CITY OF FORT COLLINS

ADDENDUM No. 2

BID #5681

FOSSIL CREEK COMMUNITY PARK

WOODEN BRIDGE PLAN
FOSSIL CREEK COMM. PARK
JOB NO. 39262.00
3/14/02
1 OF 5

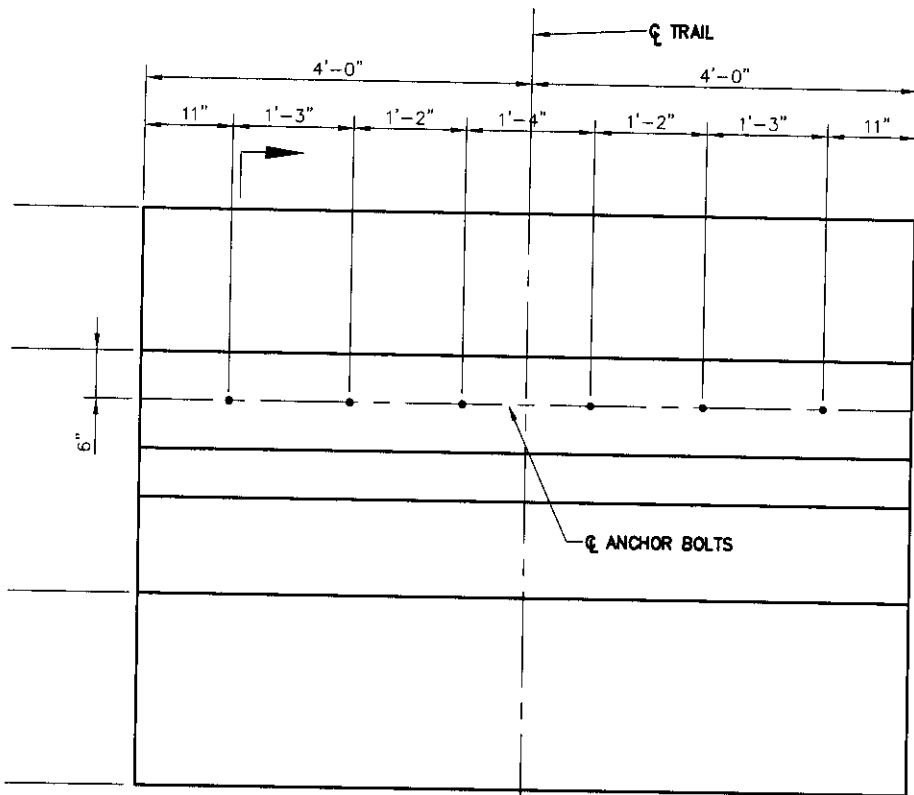
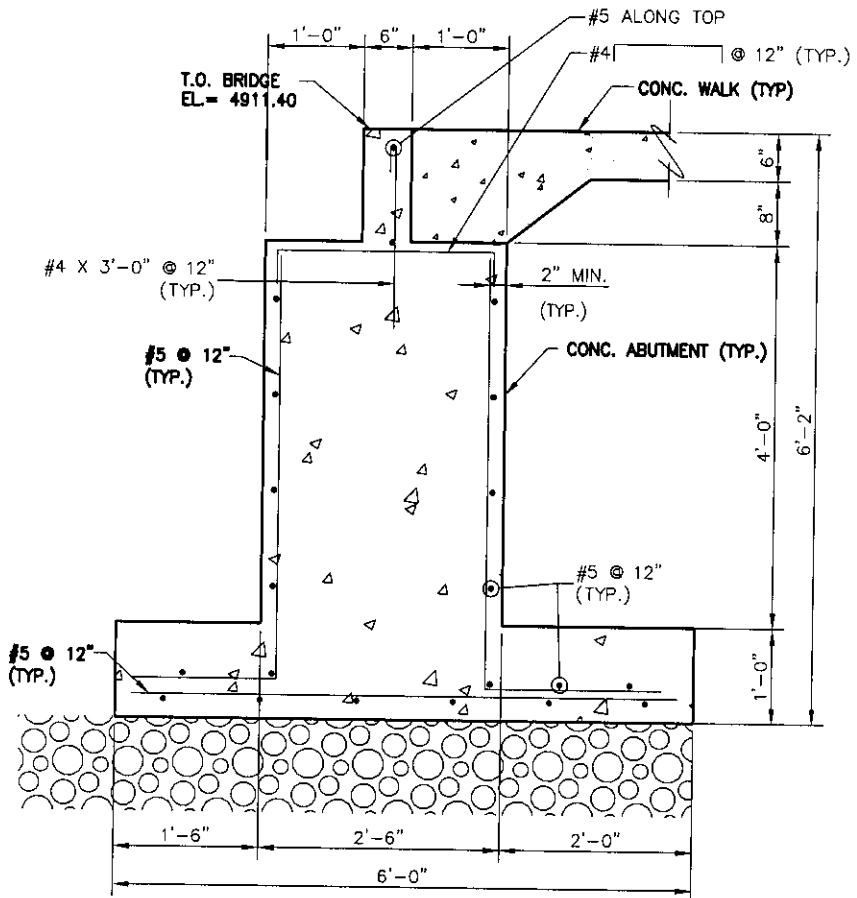
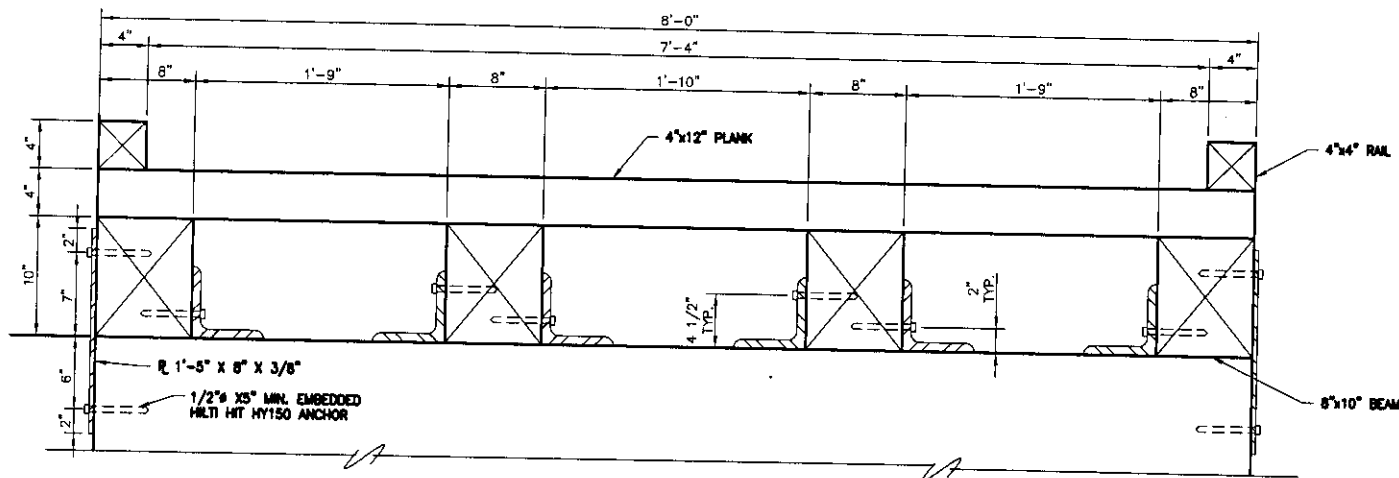
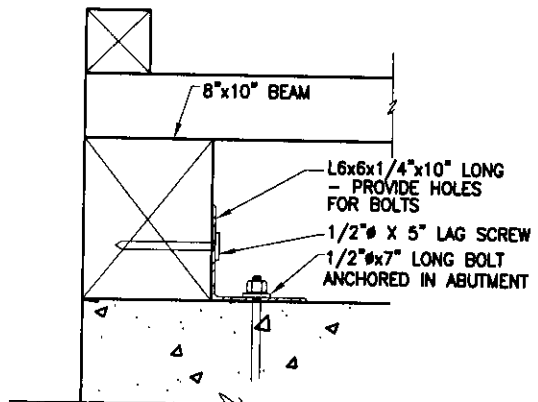
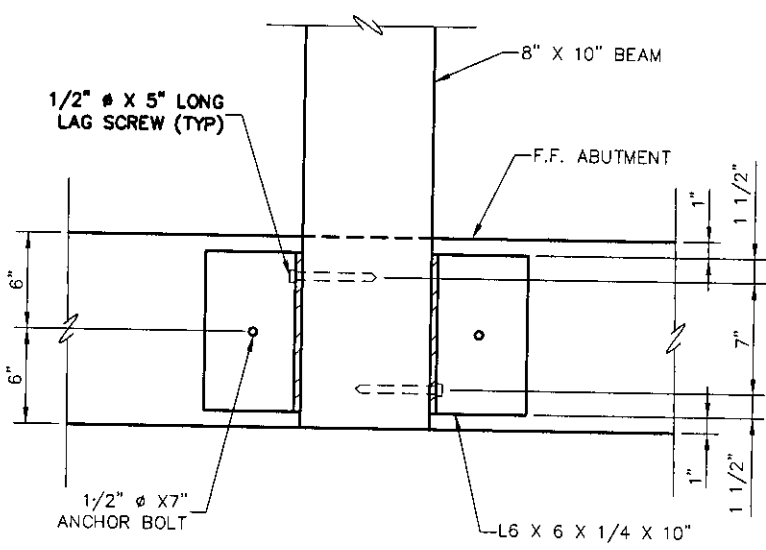
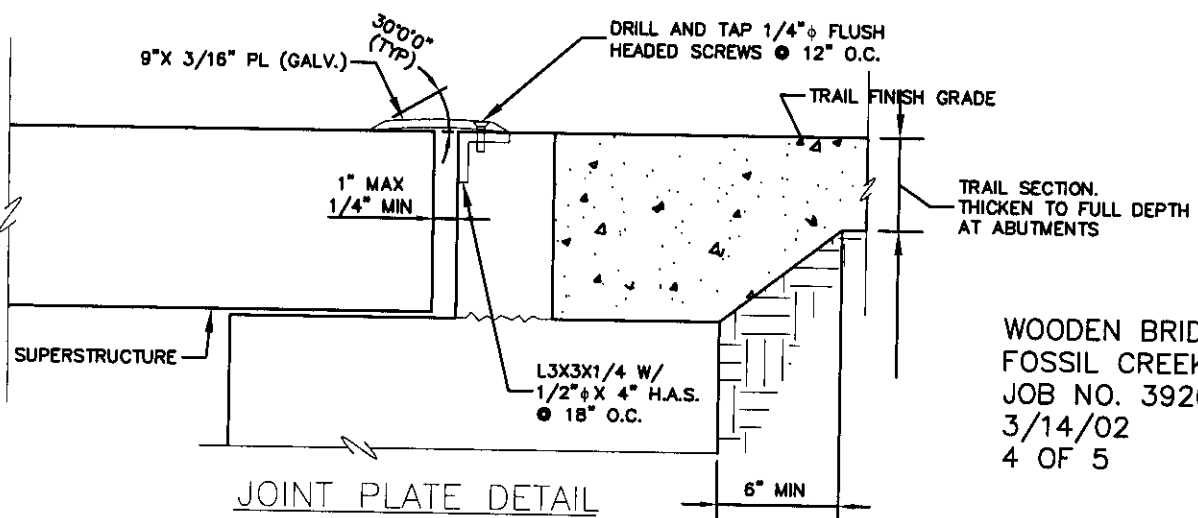
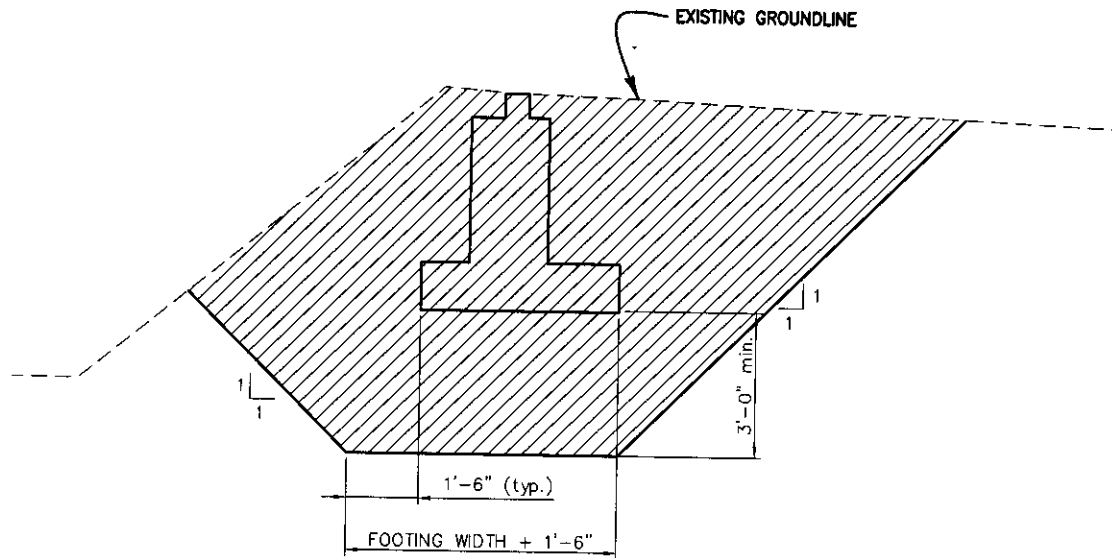
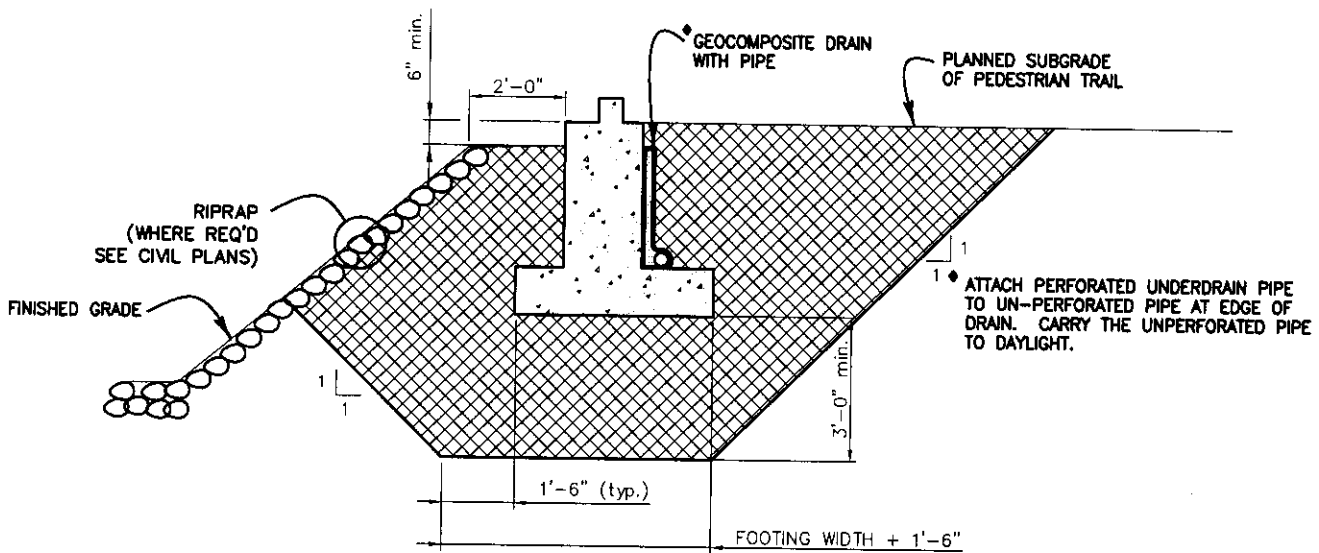
1. Wooden Bridge Plan and Details (sheet after D20.3 and before D21.1), This drawing sheet shall be replaced by the five attached 8.5 x 11 sheets
2. Sheets D21.1 and D21.2, The General Notes on these sheets apply to the concrete bridge abutments only. Refer to specification section 02890 for information regarding the bridges.
3. Sheet D4.5, Detail 1, The top rail of the chainlink fence shall be 1.625" outside diameter (not 1.875").
4. Sheets P4, P6 and P14, Unless otherwise noted, the edger around the planting beds on these sheets shall be 6" Concrete Edger.
